STATE OF OHIO
DEPARTMENT OF TRANSPORTATION
SUM-76-10.00
MAIN/BROADWAY INTERCHANGE
CITY OF AKRON, SUMMIT COUNTY

Maintenance of Traffic Subsummary

MOT PHASE 2
I-77 NB TO I-76 WB DETOUR SIGNING

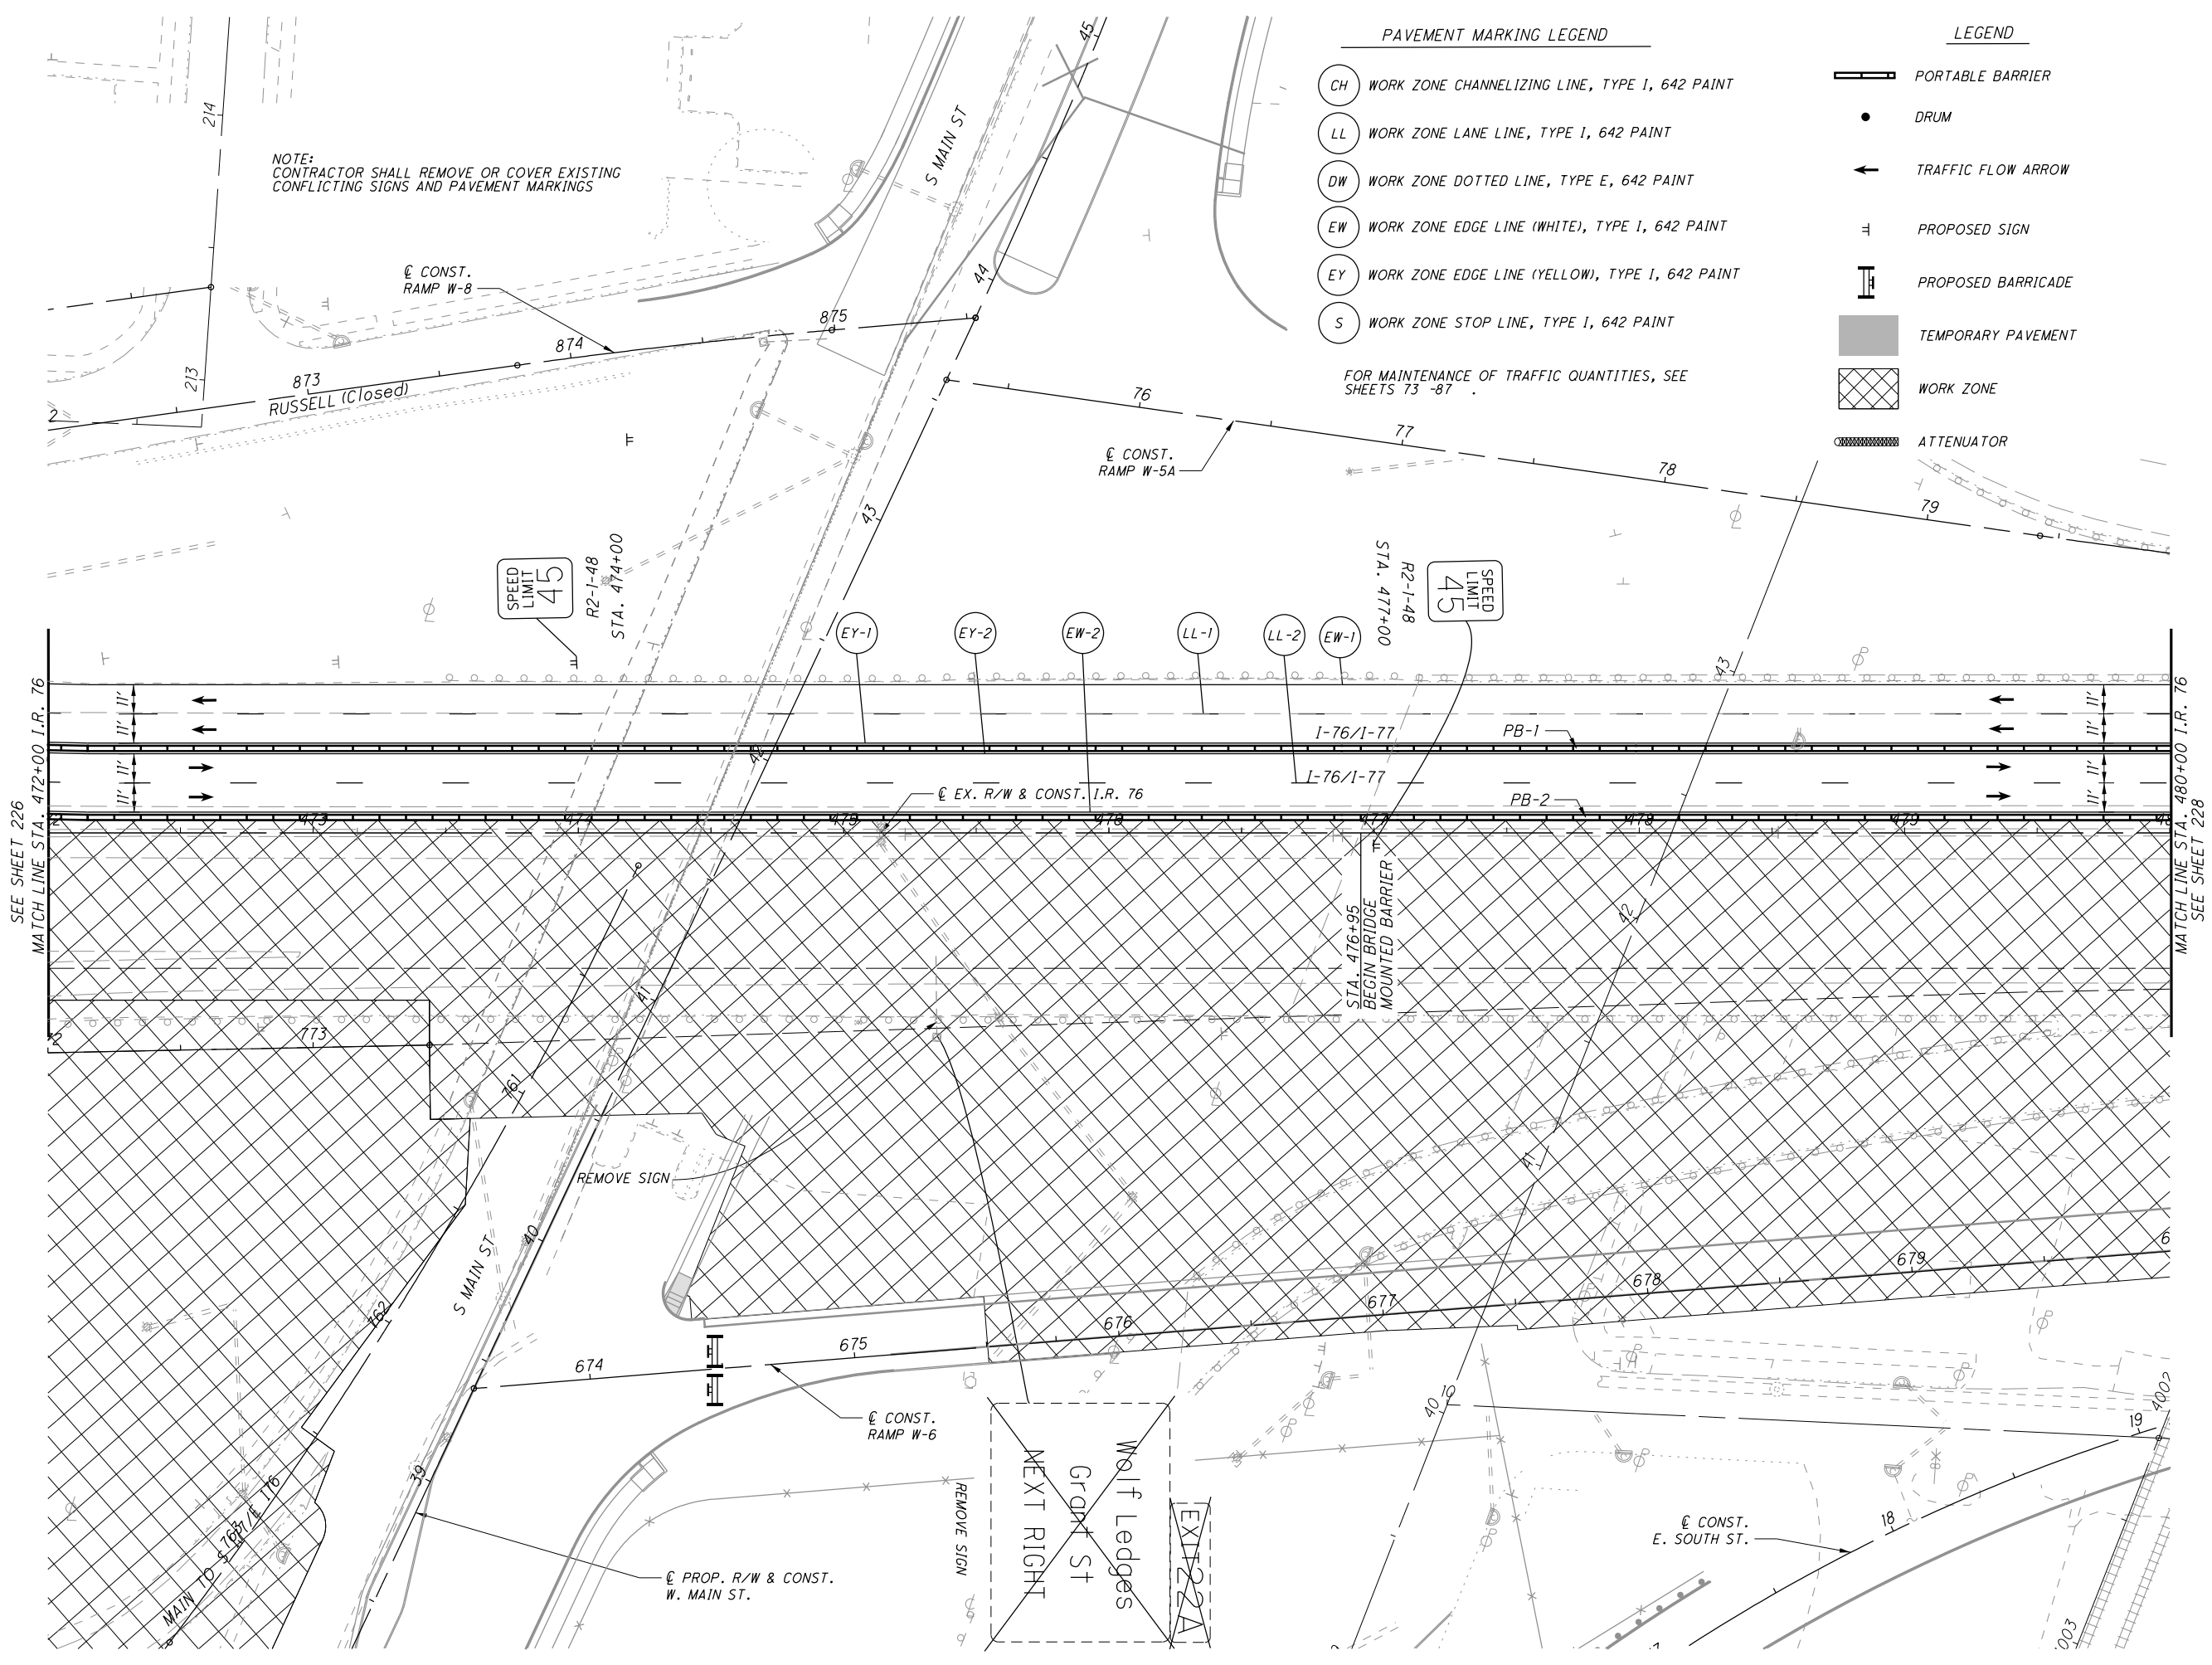
REV. BY	DATE	DESCRIPTION
KMK	3/22/16	ADDED SIGN GROUP AM

**MAINTENANCE OF TRAFFIC PHASE 2
MAINLINE - I 76 / I 77**

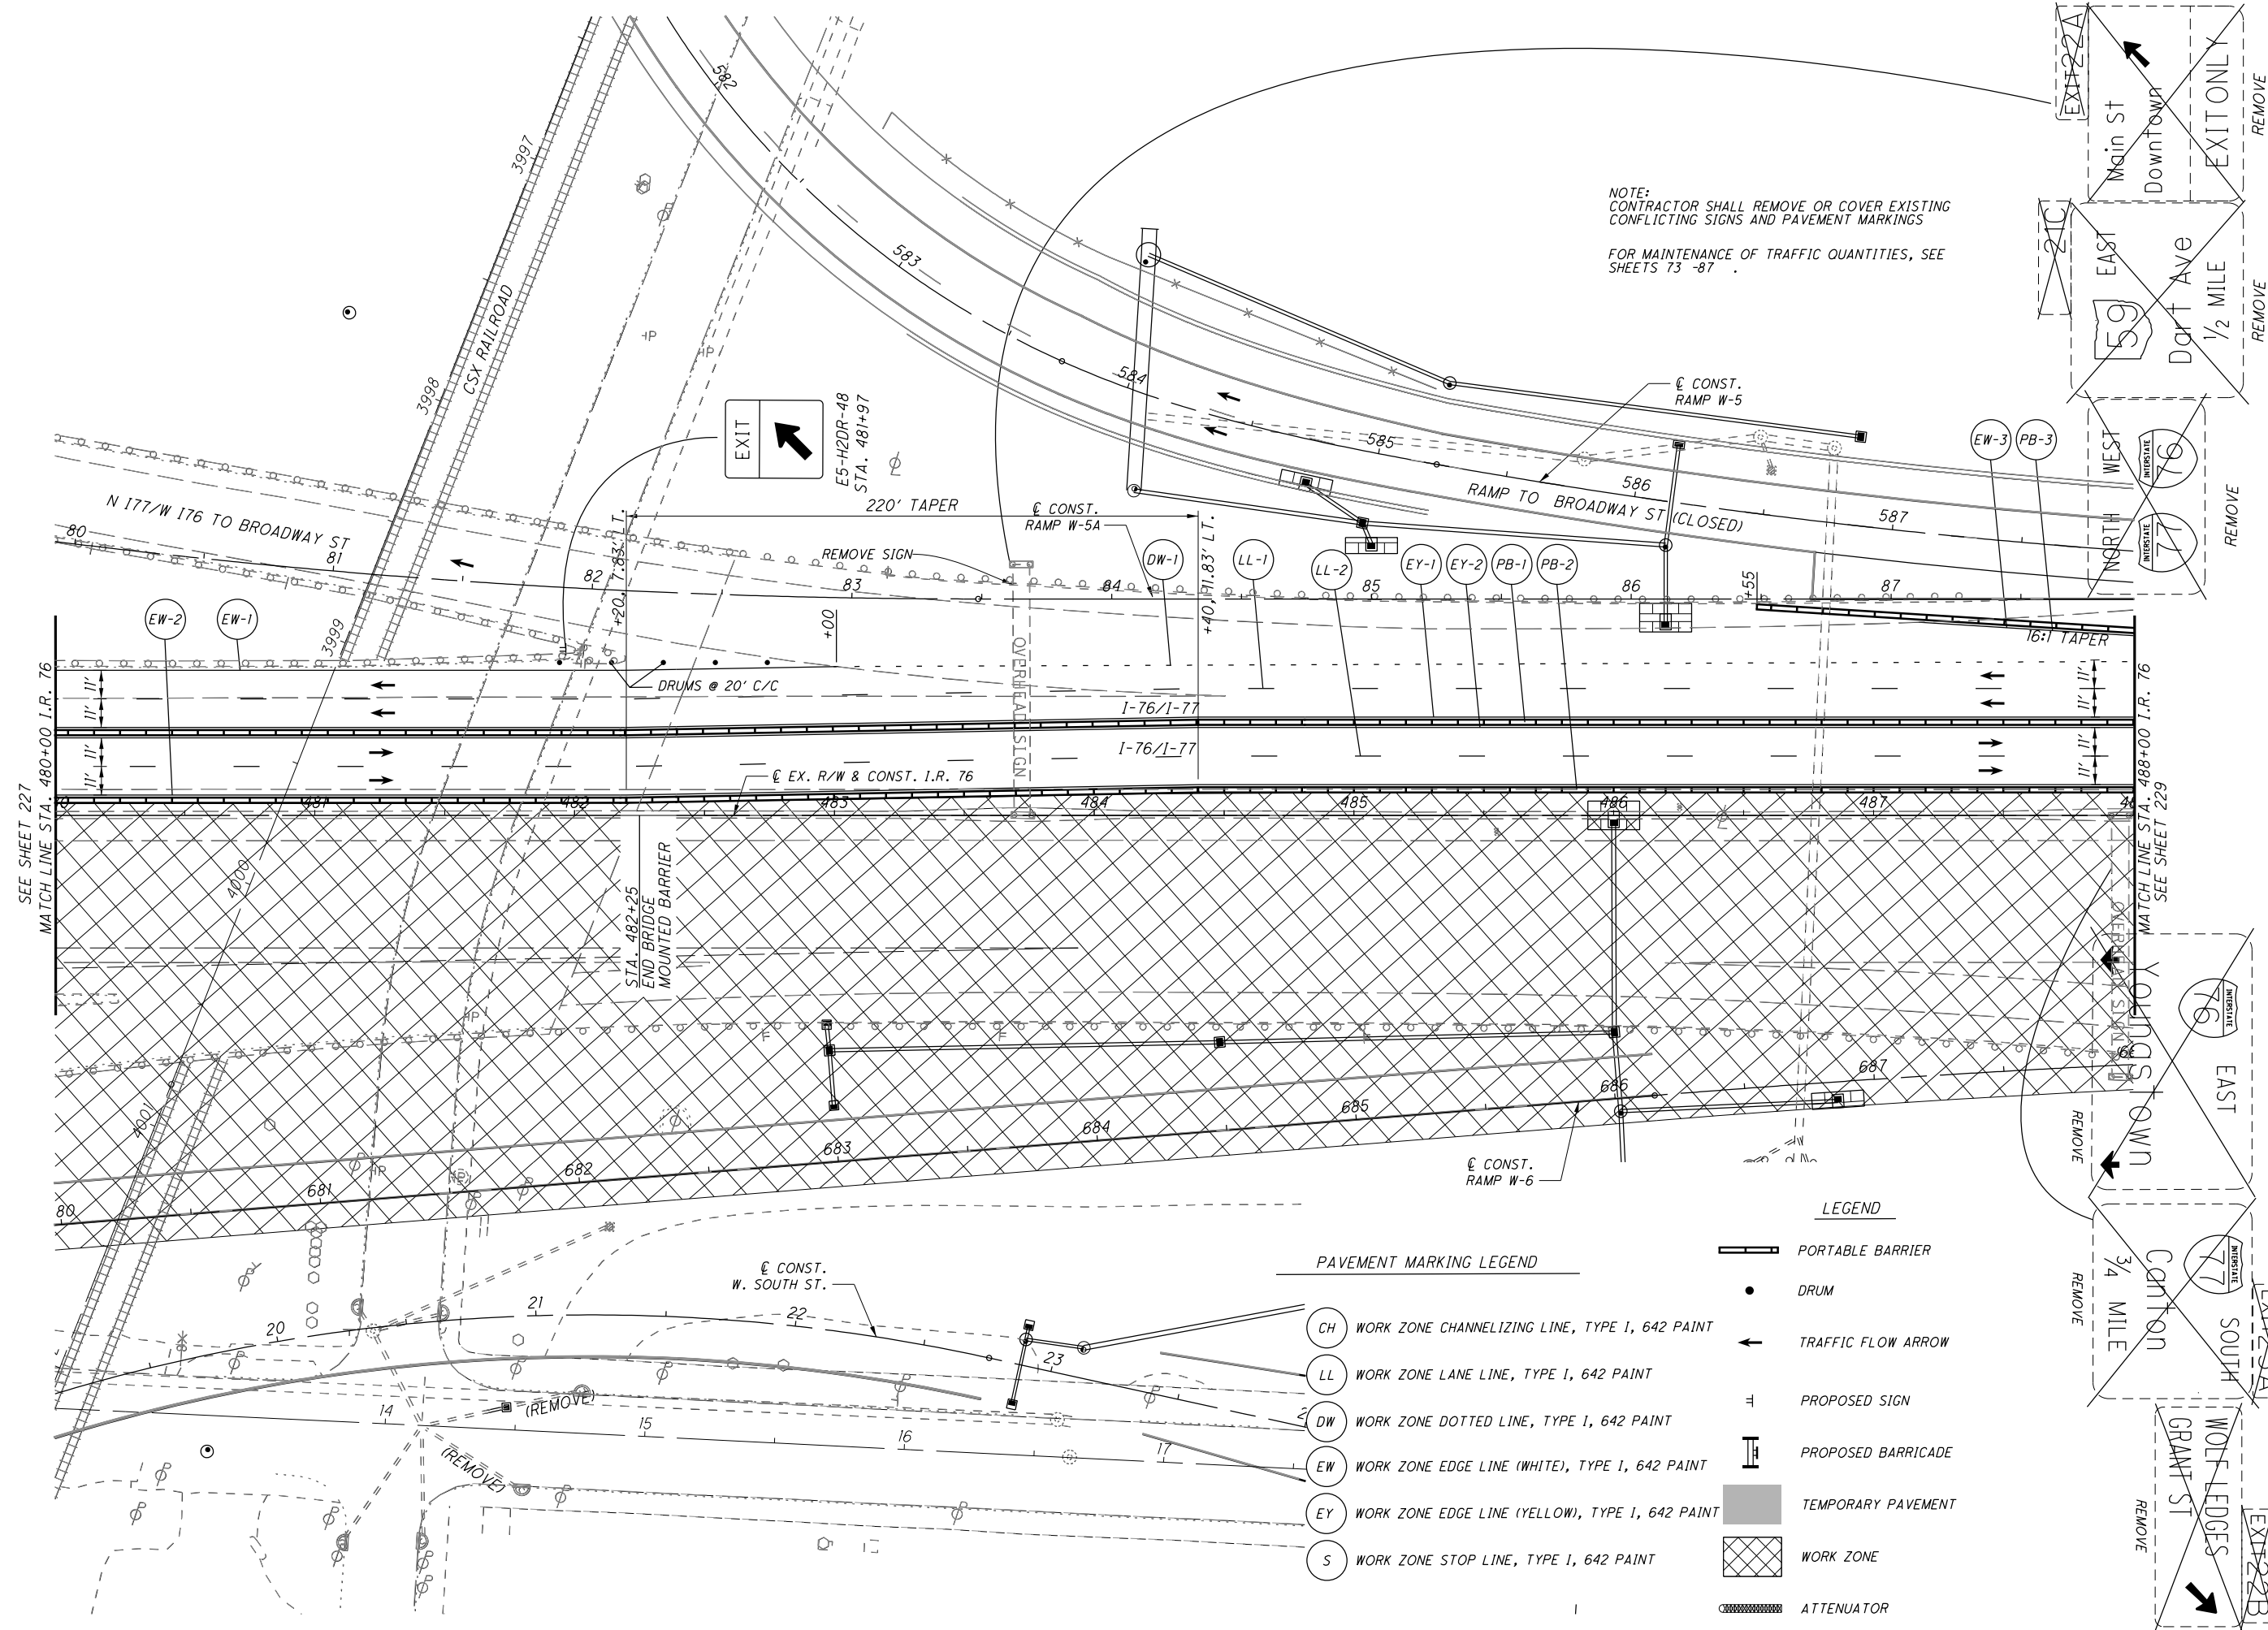
MEP 3/30/16 ADDED BRIDGE MOUNTED BARRIER CALLOUT

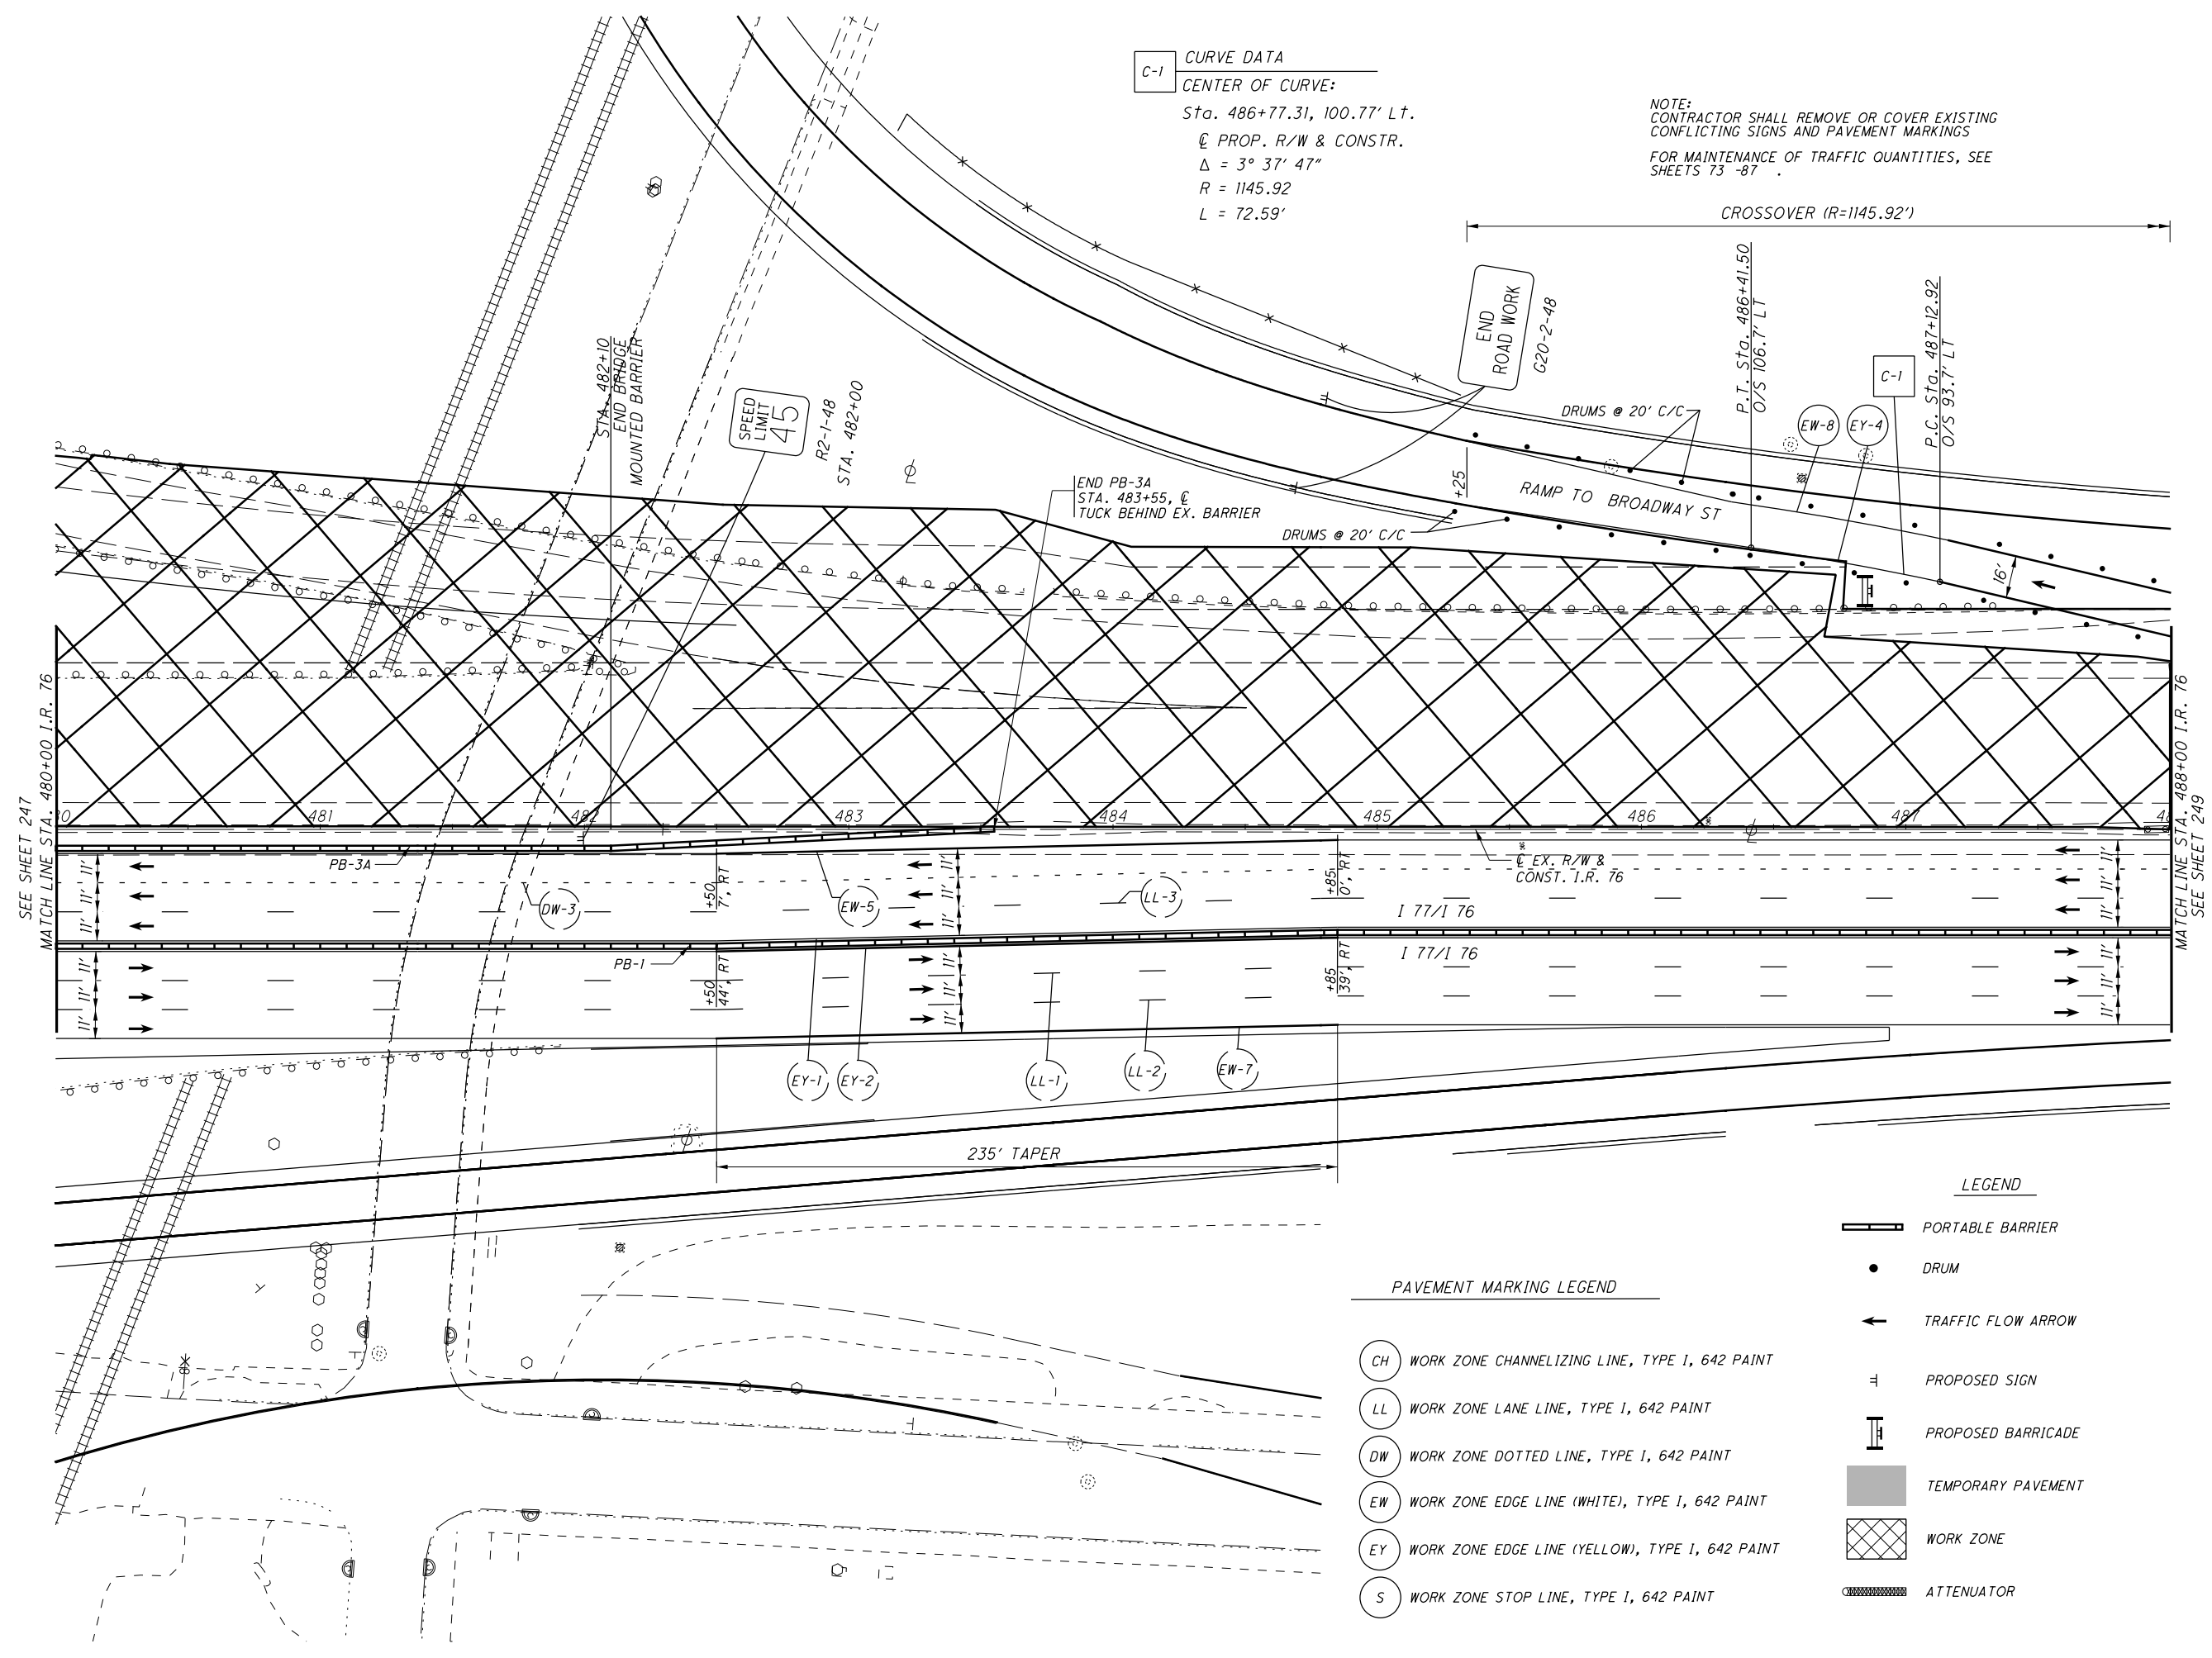
MEP 3/30/16 | PCB EXTENDED & ADDED BRIDGE MOUNTED BARRIER CALLOUT
